AMENDMENT:
 AMENDMENT ENTAILS INCORPORATING 1.46 ACRE PROPERTY INTO FOUNTAIN HILLS DEVELOPMENT, REMOVING 2.05 ACRES FROM THE PROPERTY AND MINOR ADJUSTMENTS TO THE ALIGNMENT OF FOUNTAIN HILLS PARKWAY. PARCEL SIZES HAVE BEEN AMENDED TO REFLECT THE PLAT BEING PREPARED WITH THE LAND SWAP AS REQUIRED BY THE ORIGINAL EPC APPROVAL.

Site Plan for Subdivision
 Prepared for: Fountain Hills Plaza, LLC

Project Number: 1003445
 Application Number: 07DRB-70053

ADMINISTRATIVE AMENDMENT
 File # 07-10066 Project # 1003445
 lot line adjustment to match plat
 APPROVED BY *[Signature]* DATE 9/14/07

Site Plan For Subdivision
A1

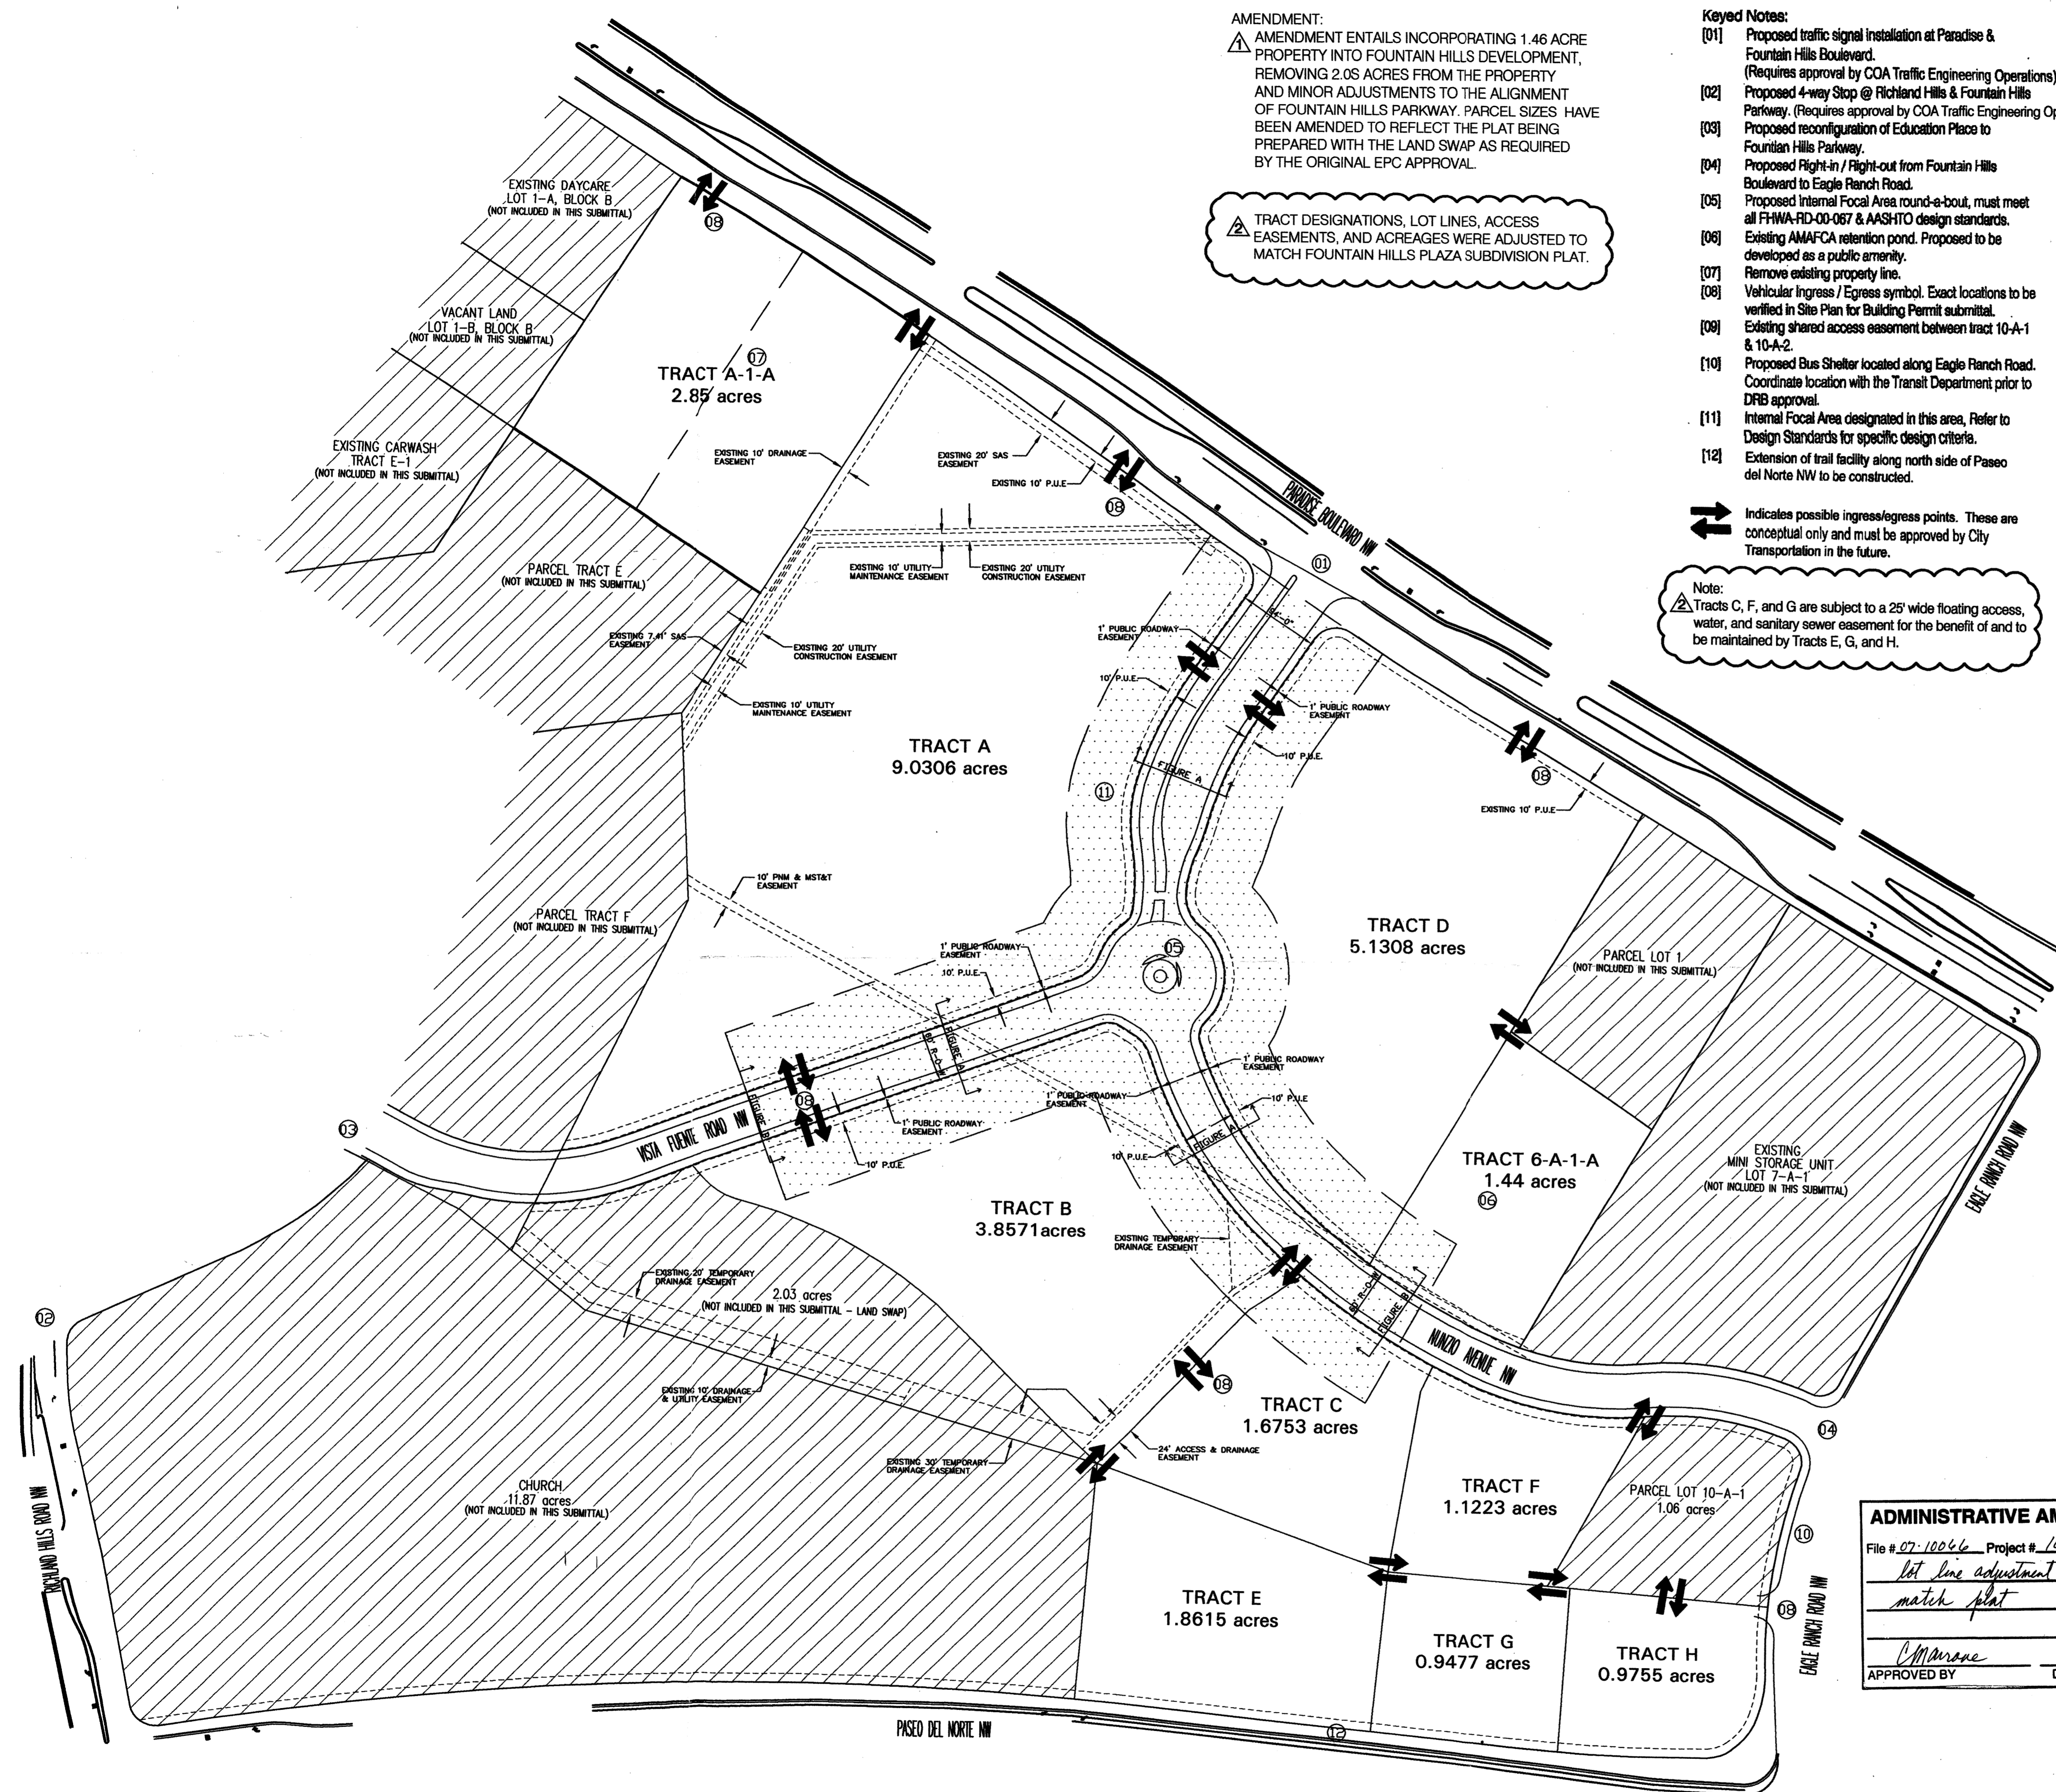
TRACT DESIGNATIONS, LOT LINES, ACCESS EASEMENTS, AND ACREAGES WERE ADJUSTED TO MATCH FOUNTAIN HILLS PLAZA SUBDIVISION PLAT.
